This Service Information bulletin supersedes SI M17 09 12 **dated November 2012.**

**NEW** designates changes to this revision

**Service Action: Retrofit of the Engine Coolant Temperature Sensor**

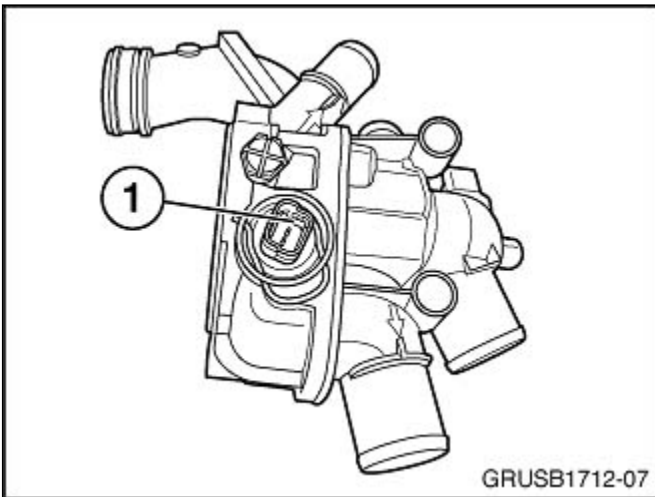
Checking for updated thermostat: The 11 53 7 534 521 thermostat has a replaceable engine temperature sensor (1).

- Replace the engine wiring harness with the 11 53 7 534 521 thermostat.
- Do not install the remote engine temperature sensor. Claim the labor operation “Check for 11 53 7 534 521 thermostat installation” in the Warranty Information section of this bulletin.
- Affix the Service Action label to the B-pillar.

## **NEW PROCEDURE ONE**

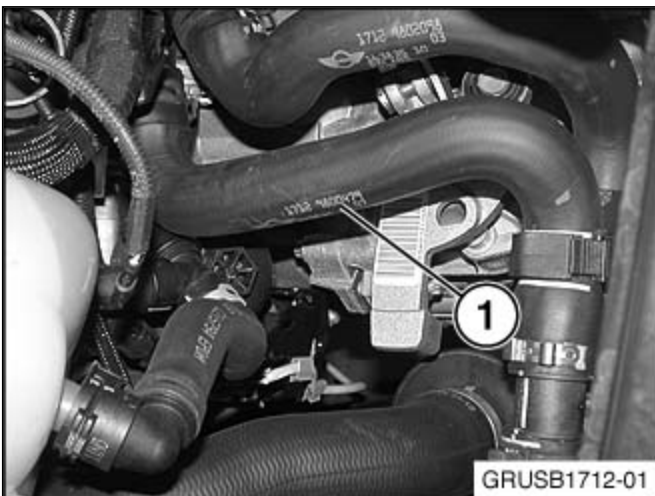
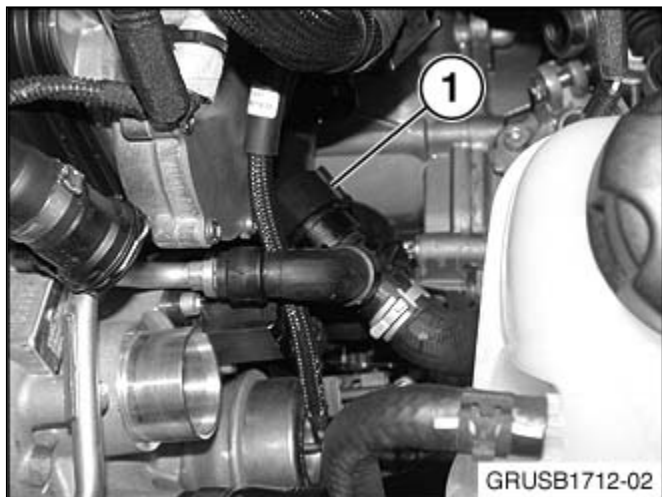
Remove the coolant hose (1). This hose will not be reused.

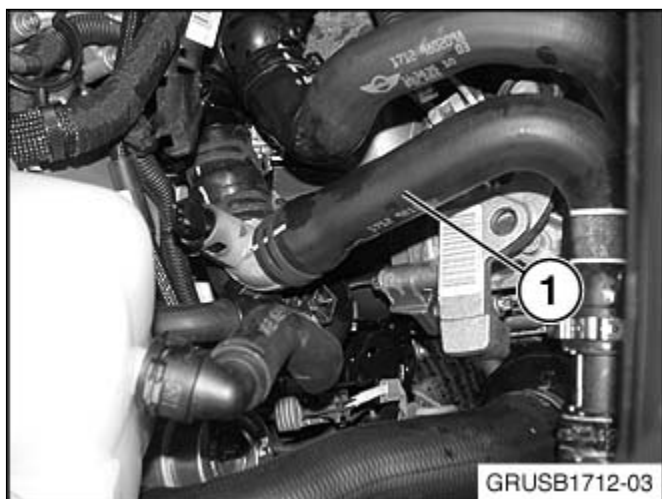
N18 engine only! Install spacer P/N 64 53 7 578 707 (1) on the coolant line as shown.

Note: The spacer needs to stay in this position when installing coolant hose P/N 17 12 9 811 352 (next step).

#### **NEW** PROCEDURE TWO

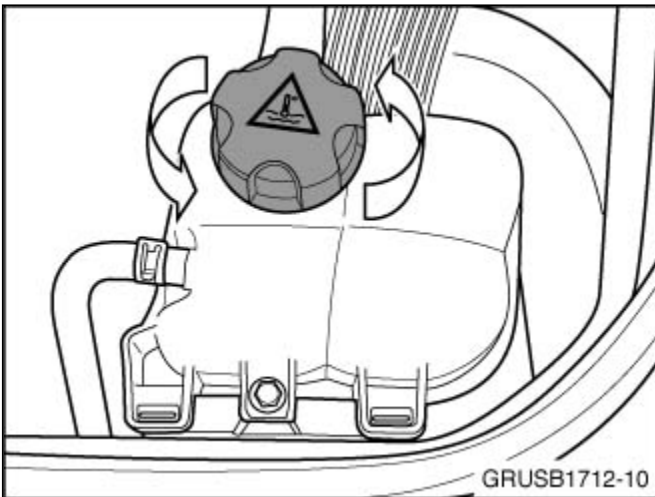
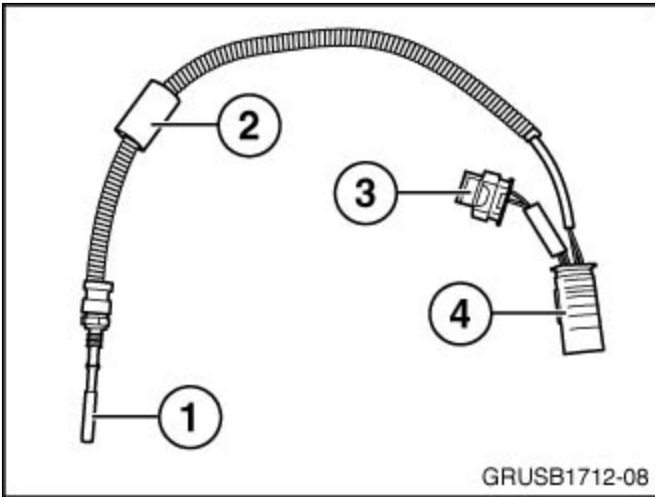
The improved sensor (P/N 13 62 8 603 908) includes the temperature probe (1) and insulating sleeve (2), a two-pin female connector (3) for the map thermostat, and a four-pin connector (4) for the engine harness.

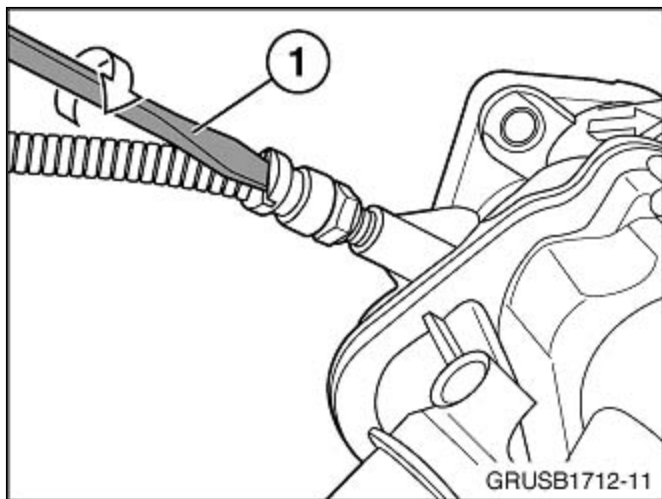
Remove the bleeder screw (1) from the thermostat. This screw will not be reused.

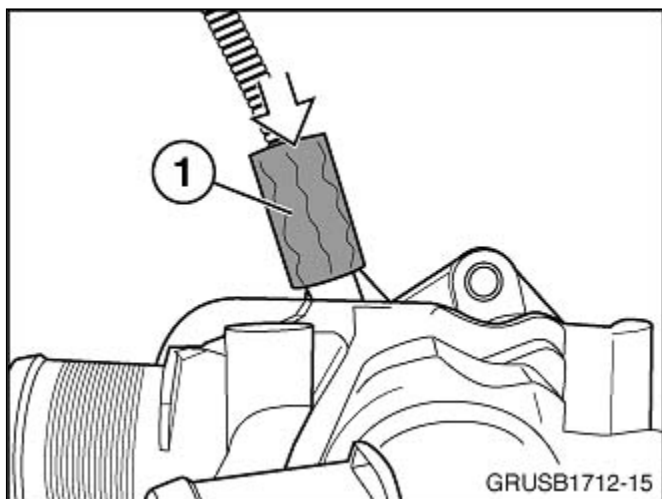
The back of the temperature sensor is slotted to accept a bladed screwdriver (1). Install the sensor into the bleeder screw hole, and torque to 2Nm.

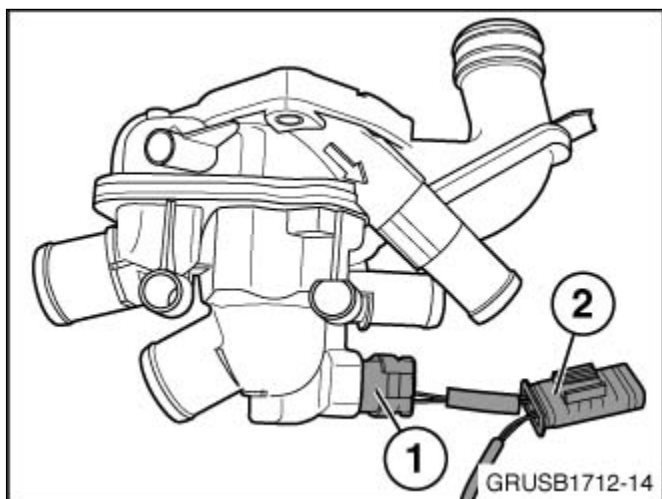
Slide insulating sleeve (1) onto the temperature sensor. The sleeve must completely cover the sensor.

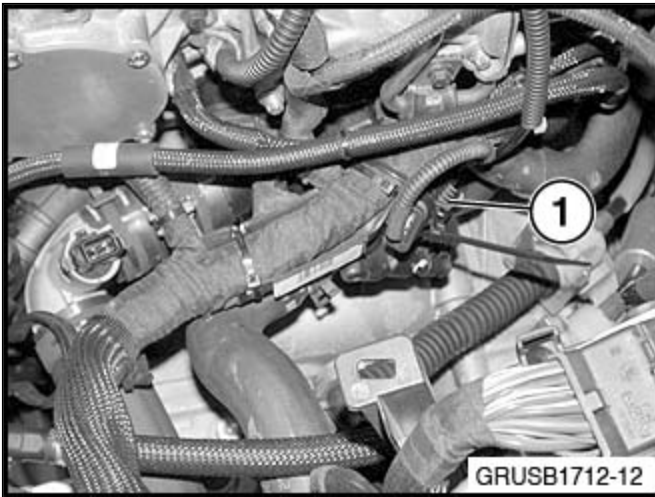
Install the two-pin female connector (1) into the thermostat and the four-pin male connector (2) into the engine wiring harness.
